## TB261 (Rev1) - GSA Rotary Table Solenoid Conversion

### **Purpose:**

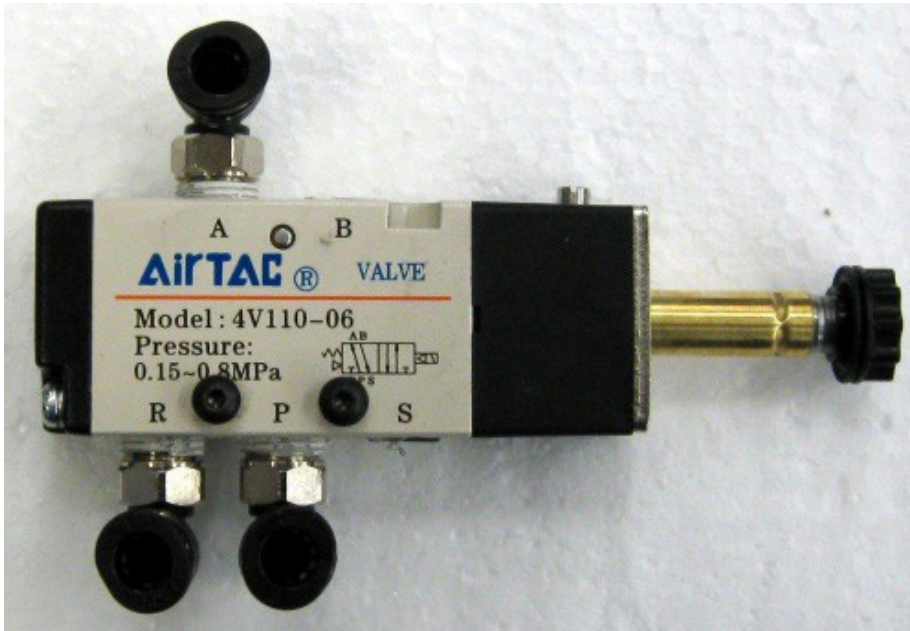
Currently the GSA rotary clamp requires 110VAC to be applied to unclamp the table. This presents a potential risk where if the 110VAC fails, the brake will be engaged allowing for damage to the rotary table if the operator tries to use the rotary table.

The solution is to change the ports on the air solenoid in the rotary table that engages and disengages the brake. When power is applied it engages the brake, making the default state unclamped instead of clamped. This eliminates the potential for damaging the rotary table if the 110VAC fails.

2. Picture of Factory Solenoid
3. Remove the plugs on ports B and S.
4. Remove the air fittings from ports A and R.
5. Put new Teflon tape on plugs and install in ports A and R.
6. Put new Teflon tape on air fittings and install on ports B and S.
7. Once completed the modified air solenoid should look like this (see picture below)

8. Modified Air Solenoid
9. Re-install solenoid and connect air lines. The line connected to "P" will stay the same, line "A" will move to "B" and line "R" will move to "S".
10. Once the rotary table is done you will need to rename the mfunc10.mac and mfunc11.mac, so mfunc10.mac will become mfunc11.mac and mfunc11.mac will become mfunc10.mac.
